RE: New 2-Family House

145 S. Fulton Avenue Mt. Vernon, NY 10553 Parcel ID: 165.80-4002-19

Review # 1

Comments: Revise and Resubmit

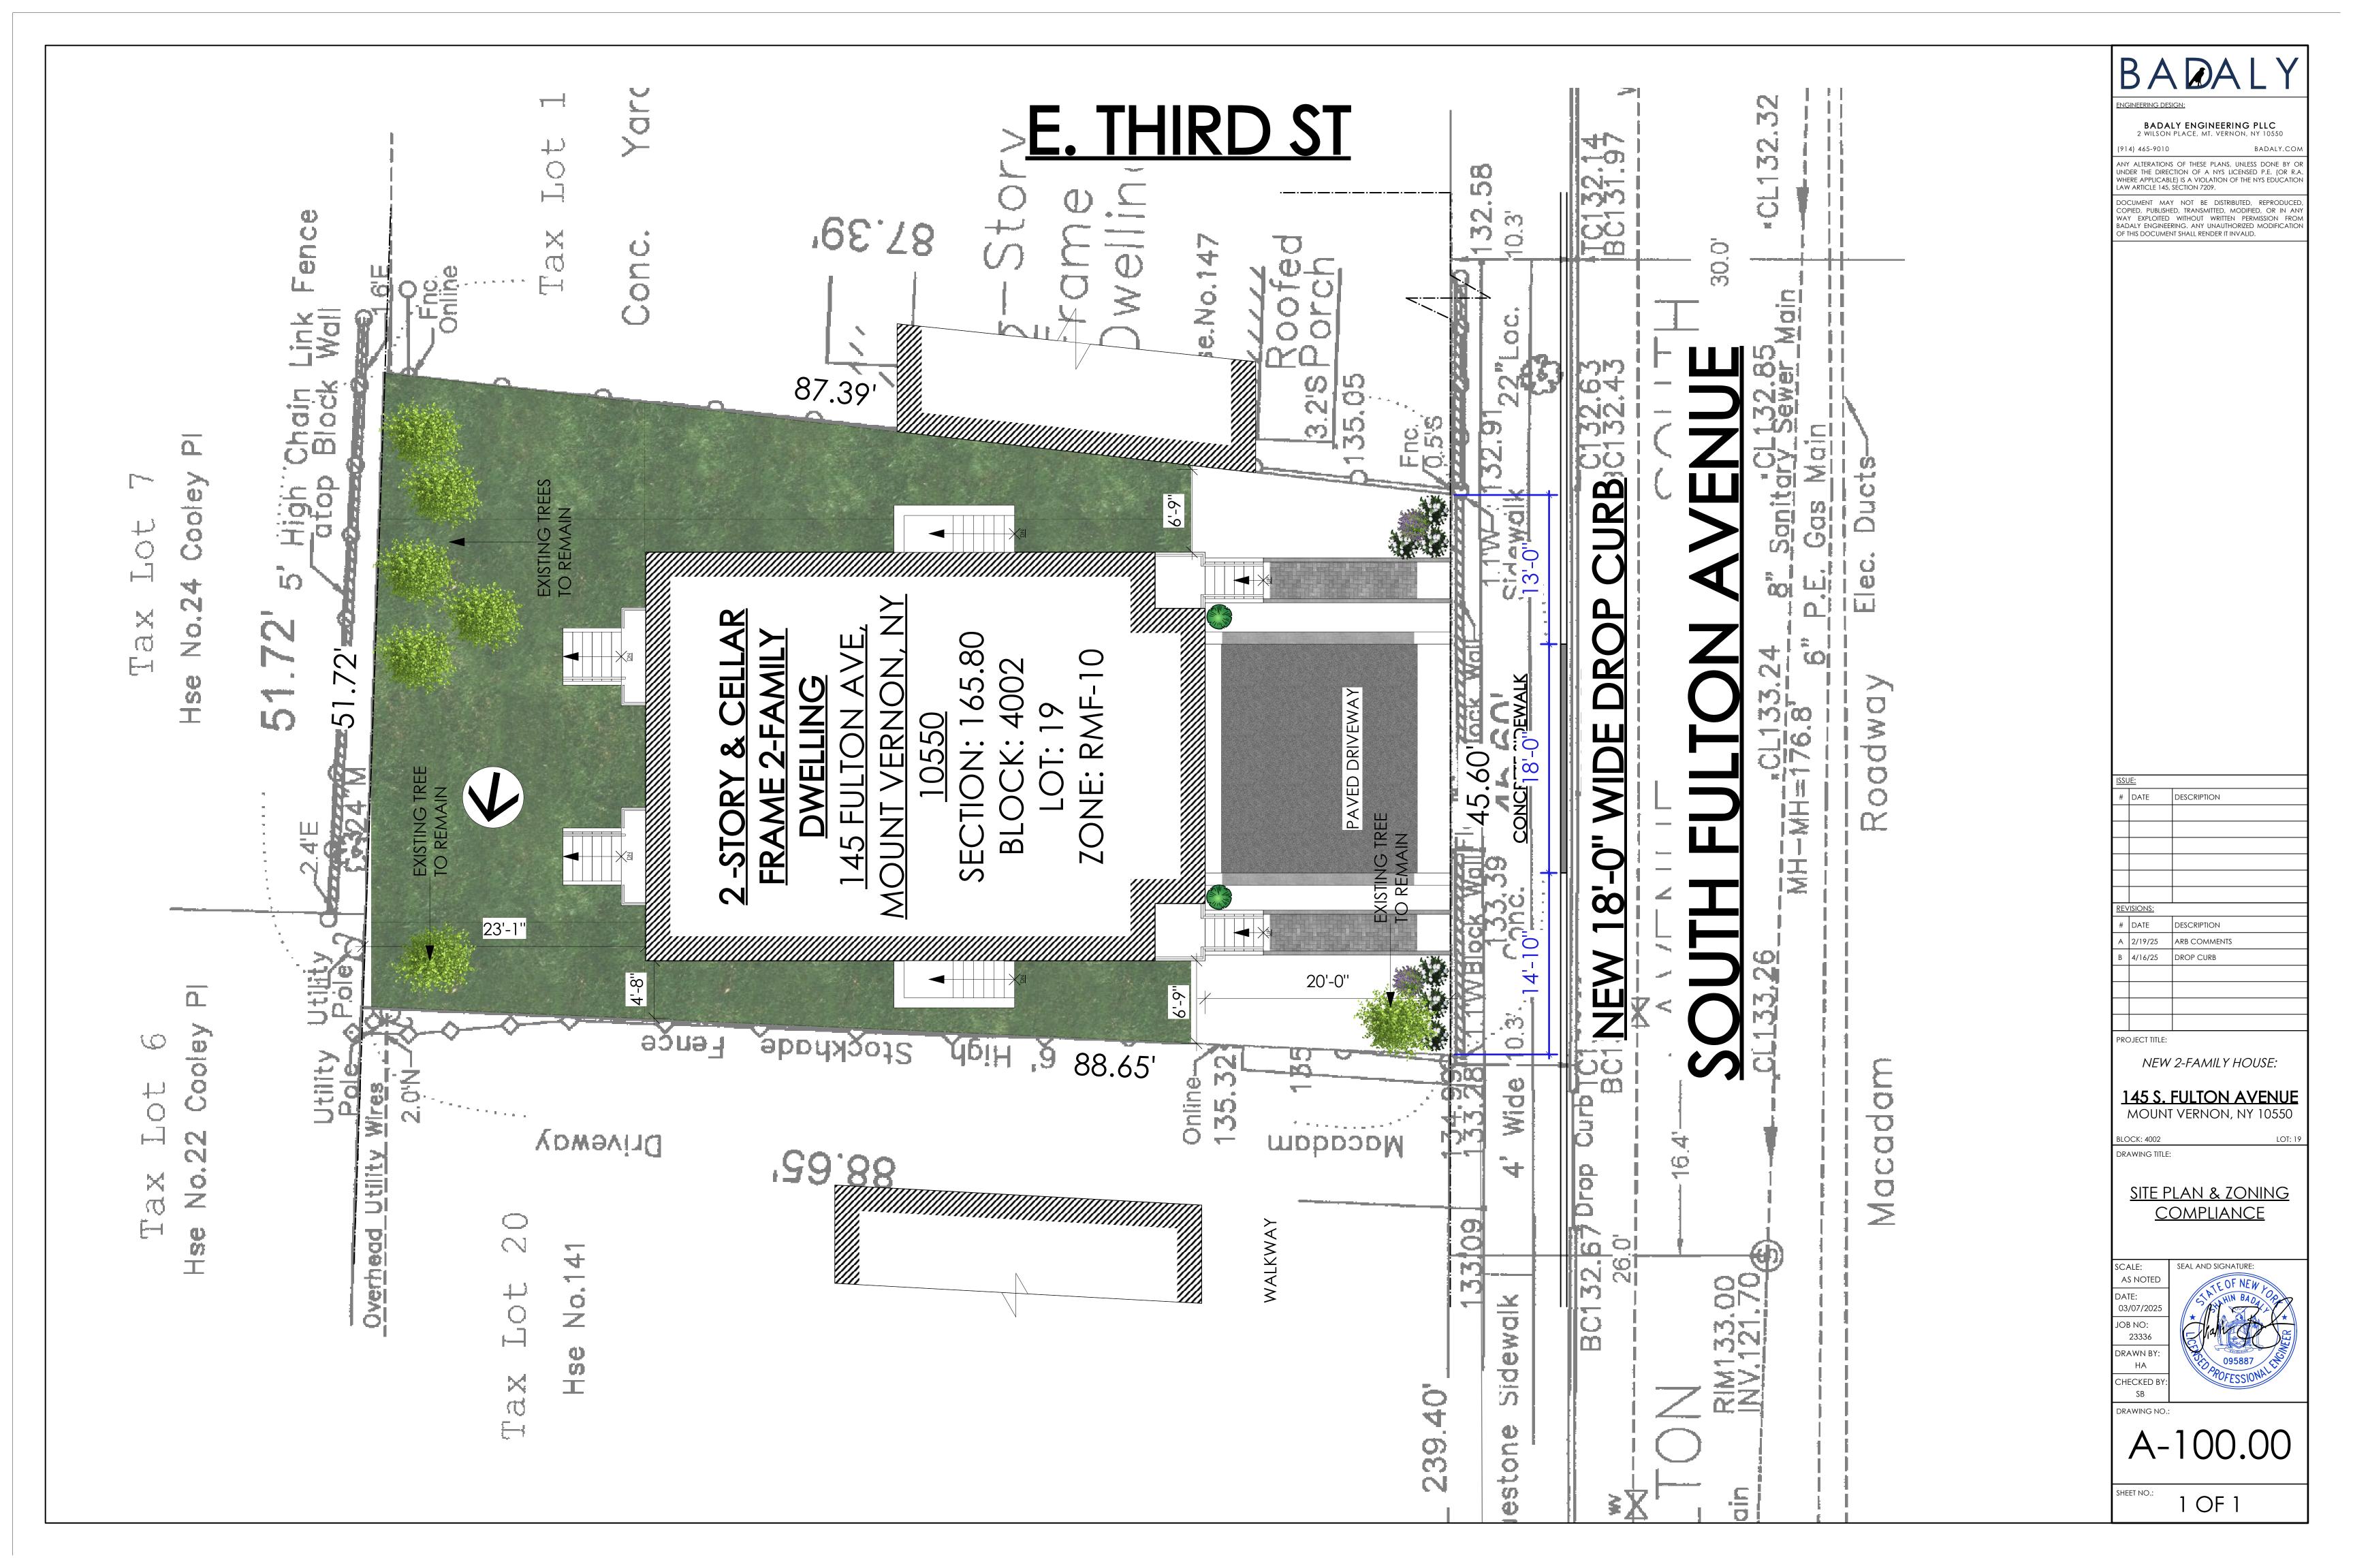
The applicant proposes to construct a new two-family detached residence on the vacant land, as well as a new retaining wall, driveway and curb cut to access the proposed garage. The driveway is proposed to be 18-0" wide and the curb cut 18-0" wide, including the curb cut splays.

We respectfully submit a City Council application for approval of the 18'-0" wide curb cut (including splays) at the above-mentioned property. Please find attached the plans for the proposed site changes.
